ROCKY MOUNTAIN ARSENAL  
**SECTIONS 26 AND 35  
CONTAMINATION SURVEY**

FINAL TECHNICAL PLAN  
DECEMBER 1987  
CONTRACT NUMBER DAAK11-84-D-0016  
TASK NUMBER 6

COLORADO DEPARTMENT OF HEALTH  
GENERAL COMMENTS ON THE  
TASK 6 DRAFT FINAL TECHNICAL PLAN

COLORADO DEPARTMENT OF HEALTH  
SPECIFIC COMMENTS ON THE  
TASK 6 DRAFT FINAL TECHNICAL PLAN

Figure 1.1-6  
TOP OF THE DENVER FORMATION:  
ROCKY MOUNTAIN ARSENAL, SECTION 26

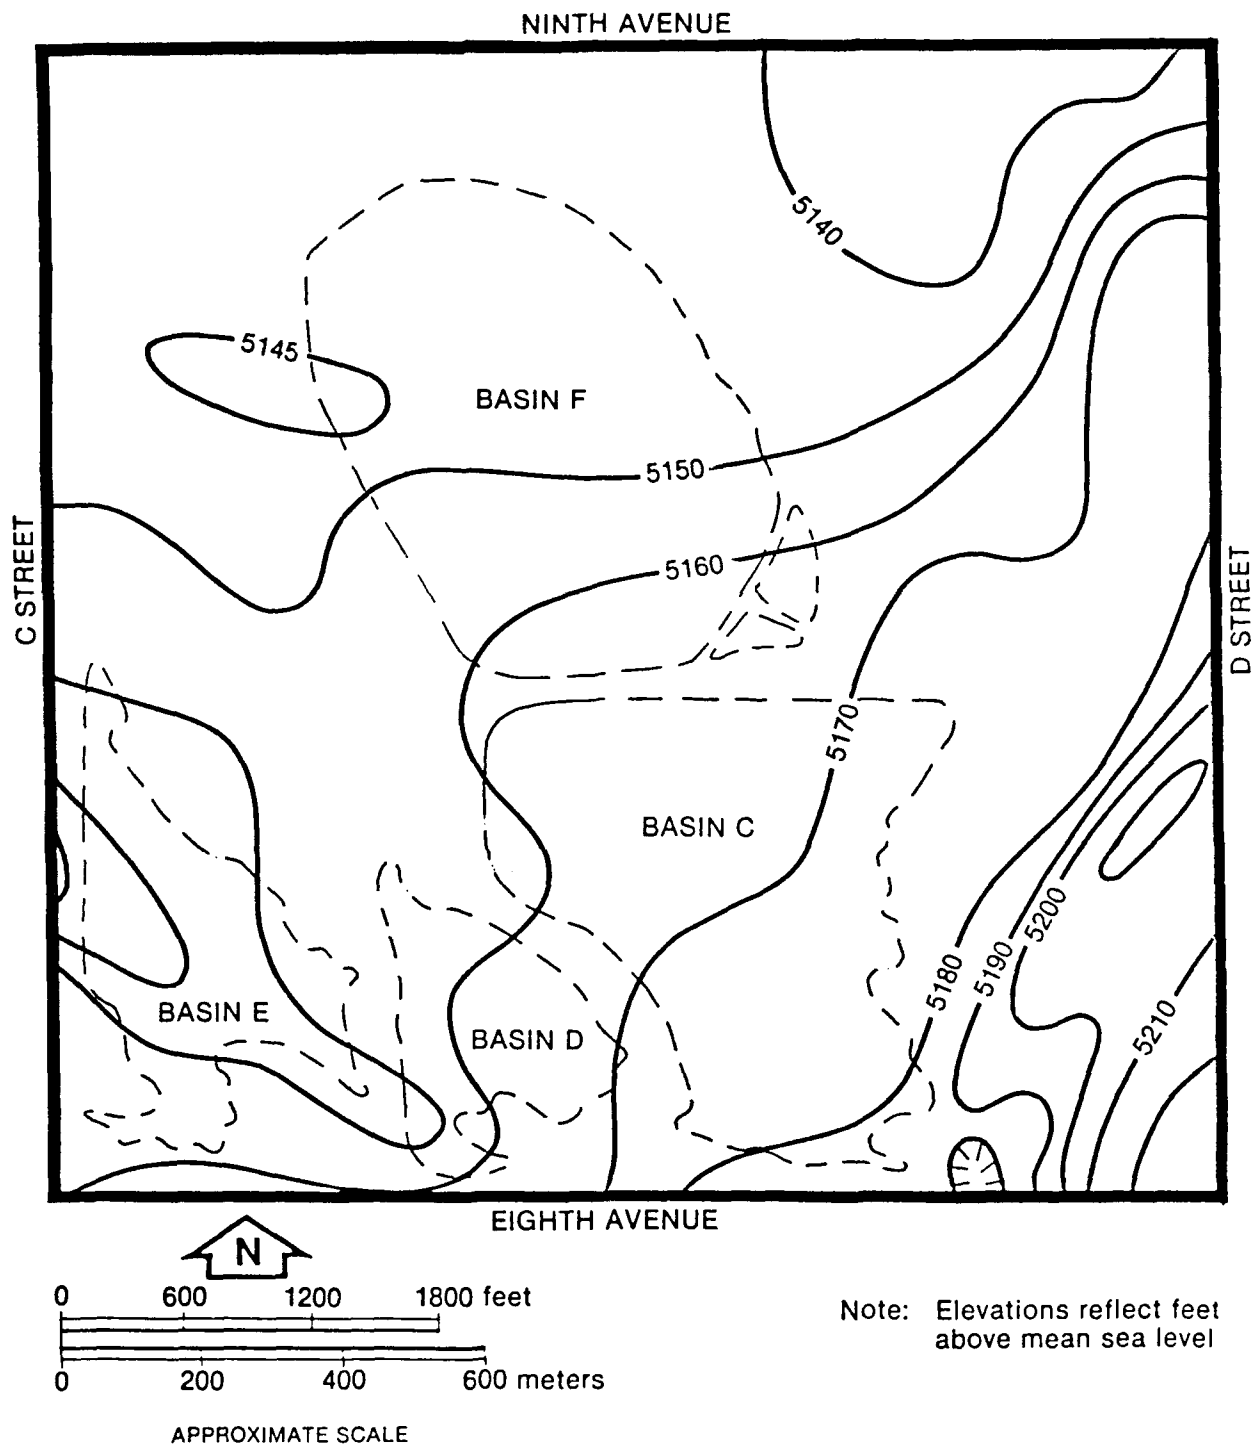
- 13 p. 1-11 Figure legend should be modified to indicate that these are elevations of the top of the Denver Formation. Why aren't data points and values shown? Please provide.

Figure 1.1-7  
TOP OF THE DENVER FORMATION;  
ROCKY MOUNTAIN ARSENAL, SECTION 35

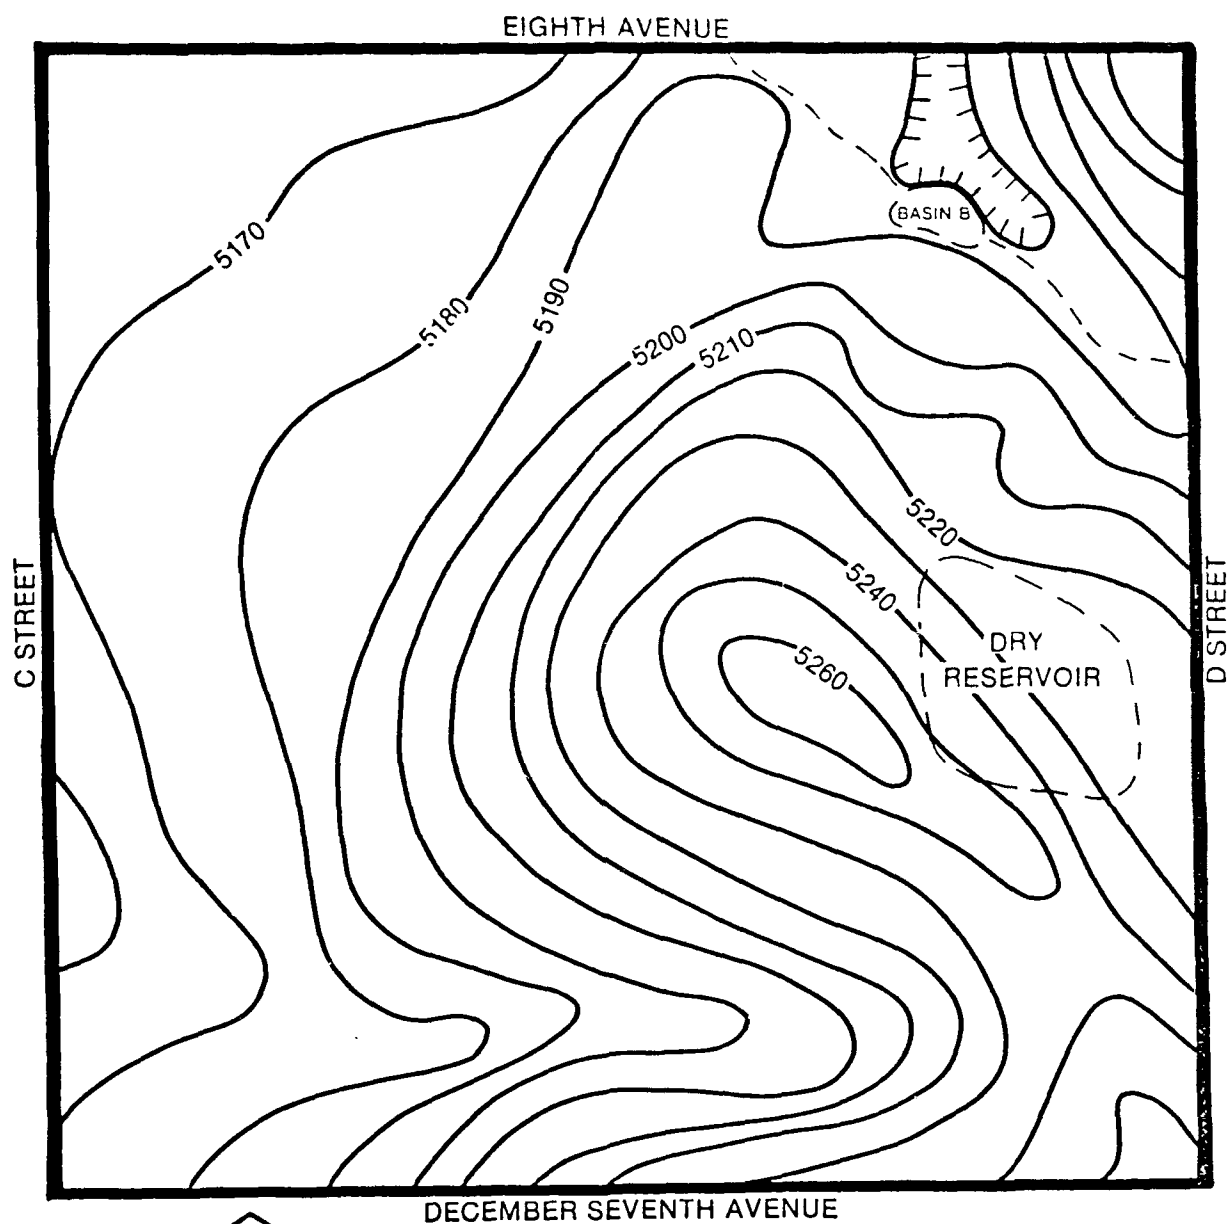
- 14 p. 1-12 Same comment as above.
- 15 p. 1-13 Change May 1982 to May (1982).
- 16 p. 1-14 Please provide data points and values. Also indicate on figure the date when water-level measurements were taken.
